**Development Review Board
Panel B Meeting
August 24, 2020
6:30 pm**

Richard Martens	Ellie Schroeder
Shawn O'Neil	Nicole Hendrix
Samy Nada	
- IV. Citizens' Input:
- V. Consent Agenda:
 - A. Approval of minutes of the July 27, 2020 DRB Panel B meeting
- VI. Public Hearings:
 - A. **Resolution No. 382. Magnolia 6-Unit Townhome Development: Base Design + Architecture, LLC. – Applicant for Hillebrand Construction, Inc. – Owner.** The applicant is requesting approval of a Stage II Final Plan, Site Design Review, and Type C Tree Removal Plan for development of a 6-unit townhome development. The site is located at 30535 SW Magnolia Avenue on Tax Lot 2101 of Section 23AB, Township 3 South, Range 1 West, Willamette Meridian, City of Wilsonville, Clackamas County, Oregon. Staff: Cindy Luxhoj

Exhibit A1
Planning Division Staff Report
SW Magnolia Avenue Townhomes

Development Review Board Panel 'B'
Quasi-Judicial Public Hearing

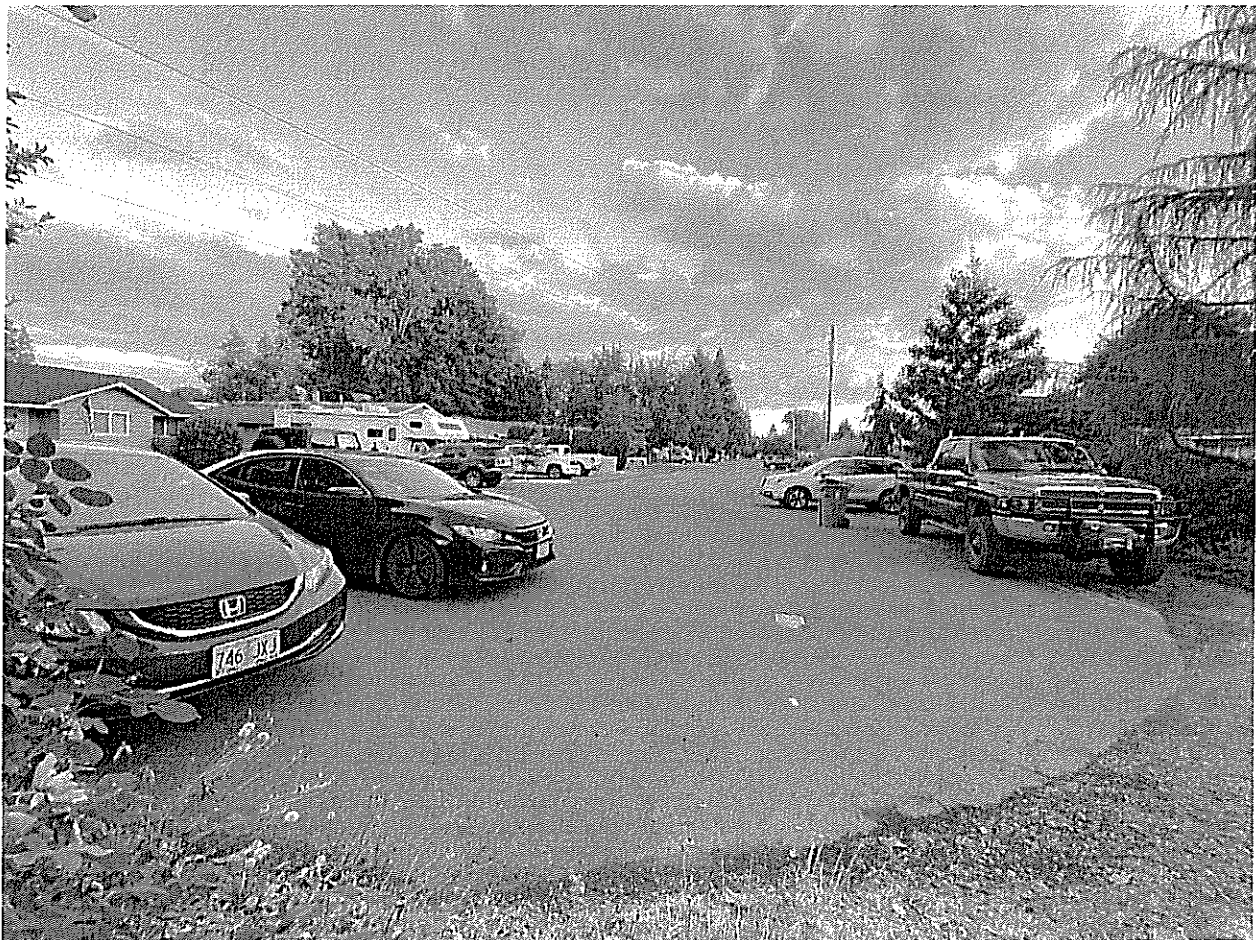
- The home of 30555 SW Magnolia Avenue is a 1920 single-story Bungalow-style home with no driveway or off street parking. There is a fire hydrant at the corner of this lot and the owners have received a parking ticket for parking too close to the hydrant.

- The home of 30560 SW Magnolia Avenue is a 1962 single-story Ranch-style home with a single car driveway and garage. Additional RV parking to the side of the lot (they have a motorhome). There is only room to park one car on the street and the residents use that spot.

Garbage day is crowded. There are 3-4 containers per house lined up on each side of the street. One each for garbage, yard debris, and recycling. There is an additional small bin for glass recycling as well. The garbage trucks have difficulty turning around at the end of Magnolia in the cul-de-sac as it is a smaller than typical cul-de-sac measuring 57' at the widest spot of the asphalt. There is really no room for additional garbage cans out on the street. Accommodations must be made for garbage pickup within the development and for the garbage trucks to be able to turn around in there as well. There doesn't look like enough room in the existing plans for this.
